LOCAL HISTORIC DISTRICT: Dilworth

PROPERTY ADDRESS: 1015 East Boulevard

SUMMARY OF REQUEST: Addition, window replacement

Charlotte Historic District Commission Case 2018-496
HISTORIC DISTRICT: DILWORTH
ADDITION

Front Elevation – First Review and Revised Plan

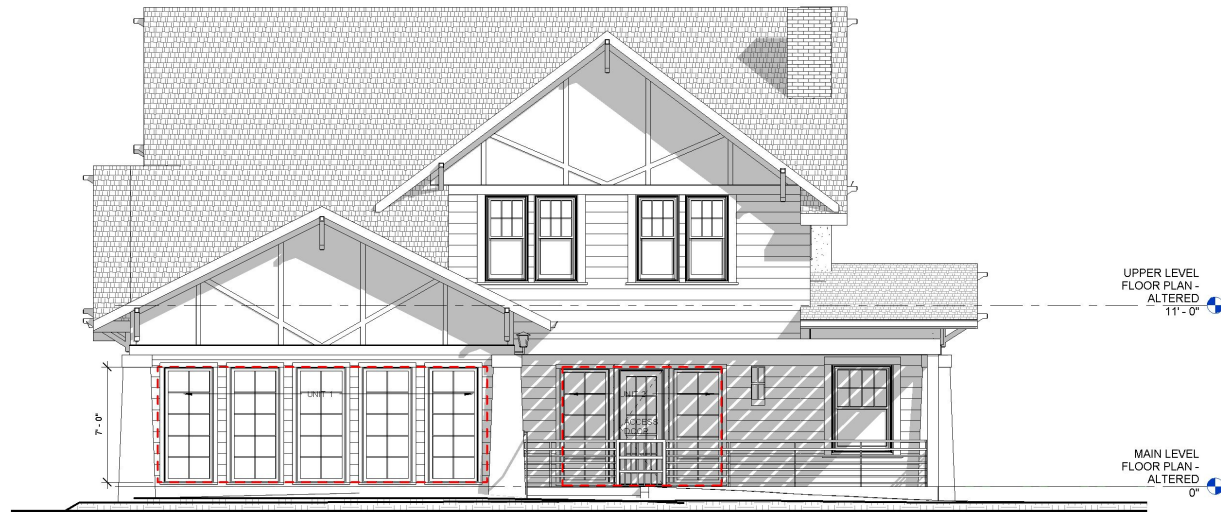
1. Save trees in front yard and provide a tree protection plan.
2. Keep the tapered columns.
3. Meet guideline for front entrance and canopy per guideline 4.10, item 6.
4. Relook at an accessible entrance based on guideline 8.10, item 1.
5. Retain existing windows on all elevations.
